**WILSONVILLE CITY HALL  
DEVELOPMENT REVIEW BOARD PANEL A**

**MONDAY, FEBRUARY 9, 2015 - 6:30 P.M.**

**REVISED STAFF REPORT  
WILSONVILLE PLANNING DIVISION  
Conditional Use Permit  
Ridder House Offices  
DEVELOPMENT REVIEW BOARD PANEL 'A'  
QUASI-JUDICIAL PUBLIC HEARING**

Exhibit A1  
**STAFF REPORT**  
**WILSONVILLE PLANNING DIVISION**

EXHIBIT C6

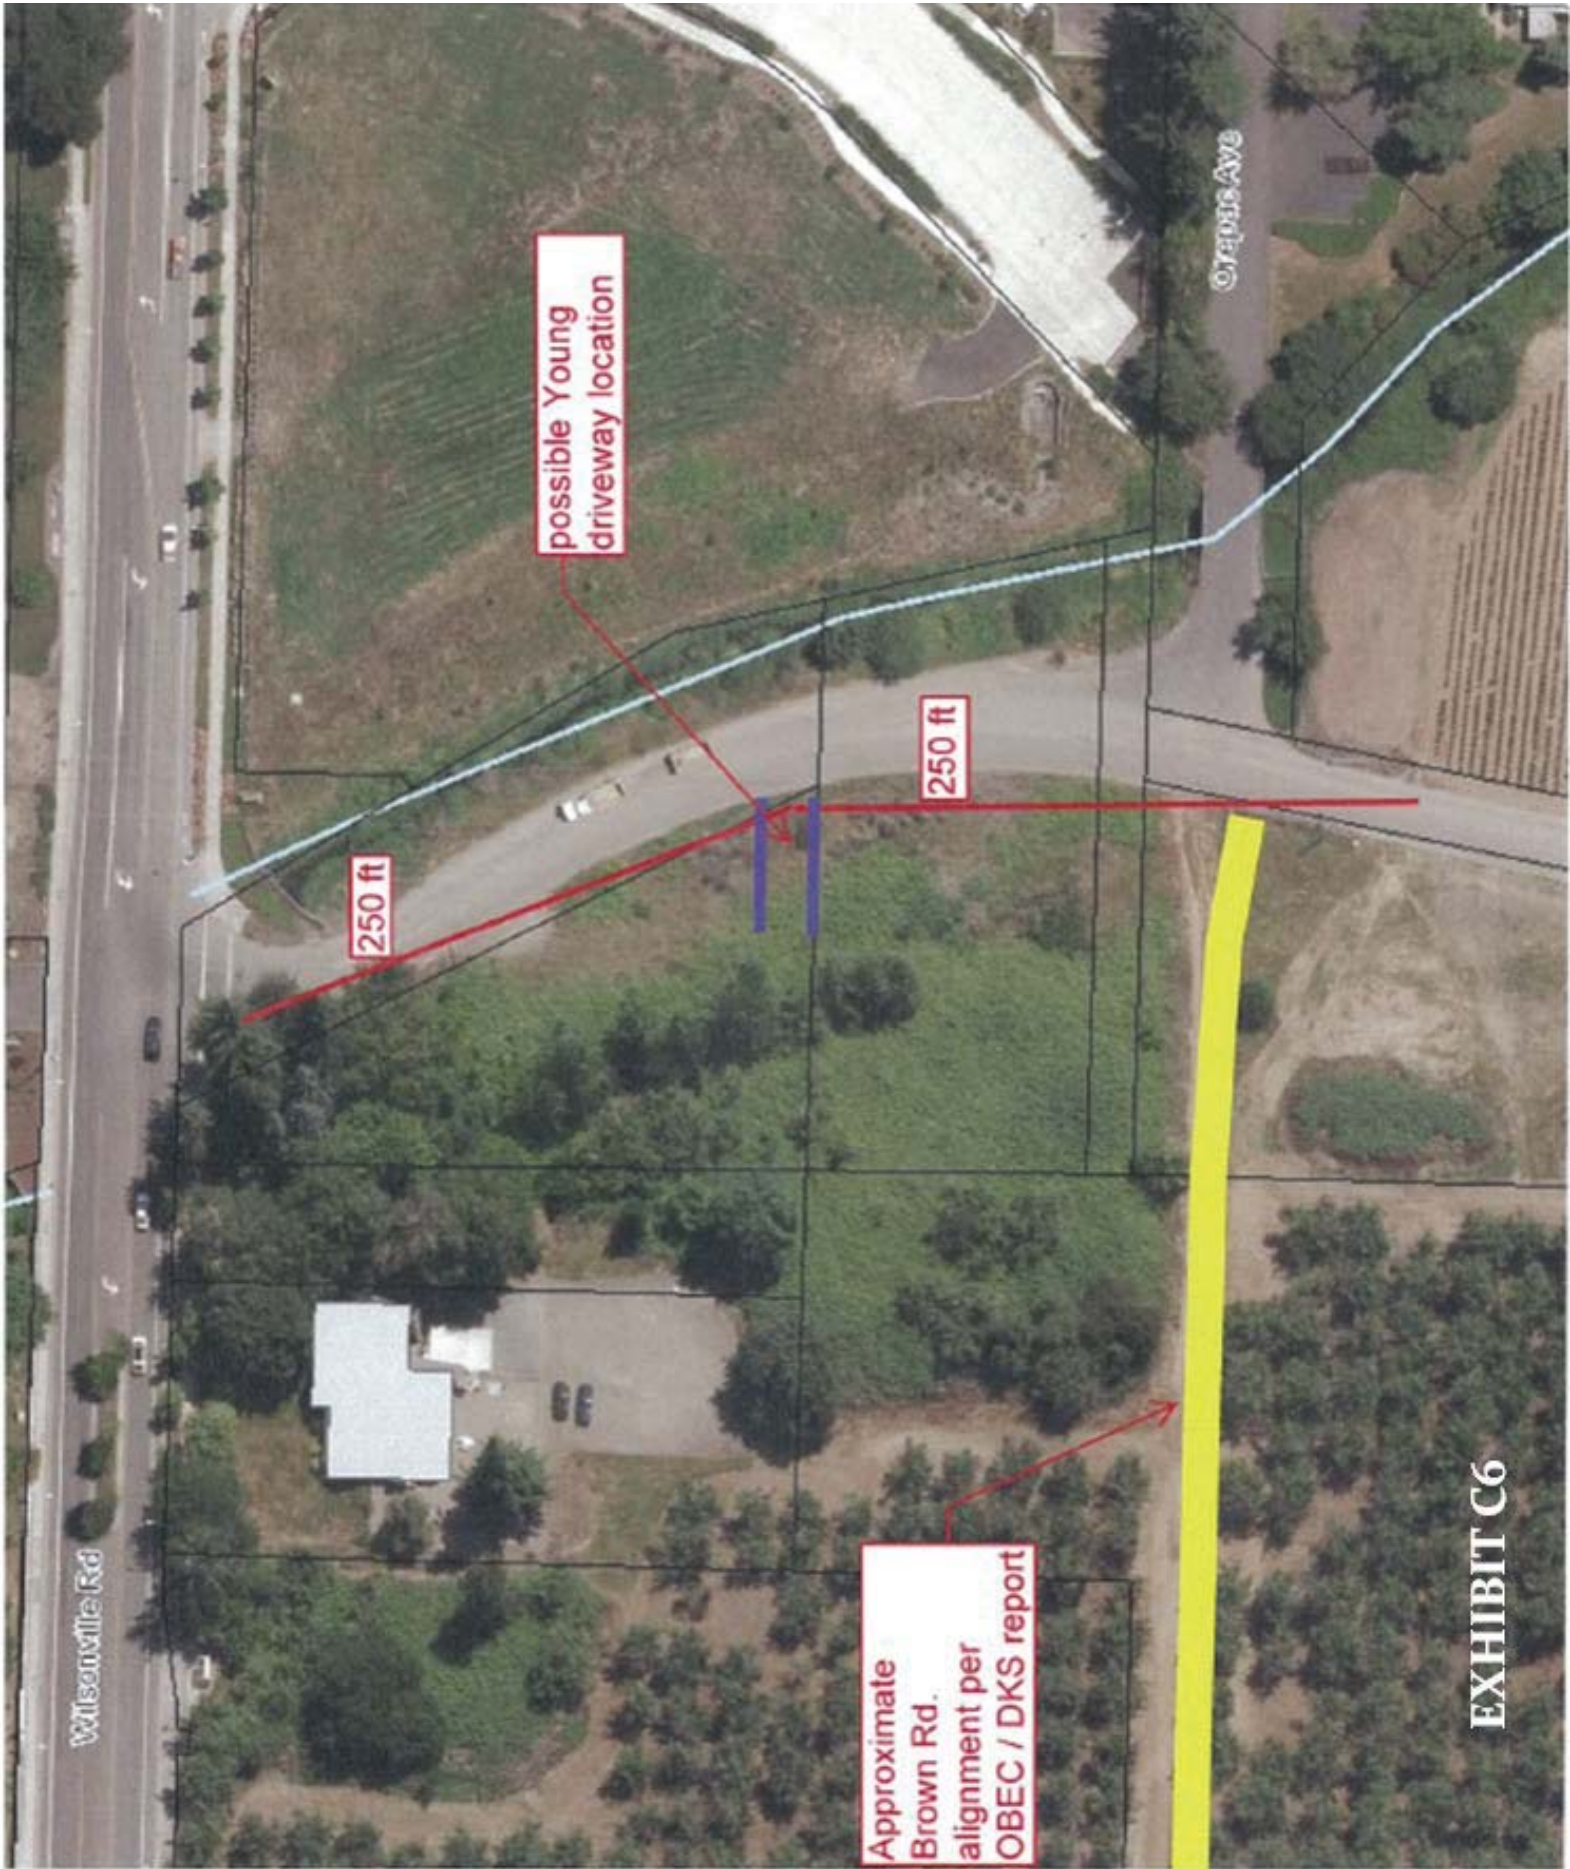
Driveway appears to split these two lots and does not lie on the Young parcel.

***The applicant has provided the required evidence to demonstrate that the subject driveway at SW Wilsonville Road is entirely at the applicant's property. The applicant has indicated to staff that he is completing an access agreement with the easterly adjoining property owners represented by Sheri Young. Thus the DRB can approve the revised staff report, conditions and exhibits.***
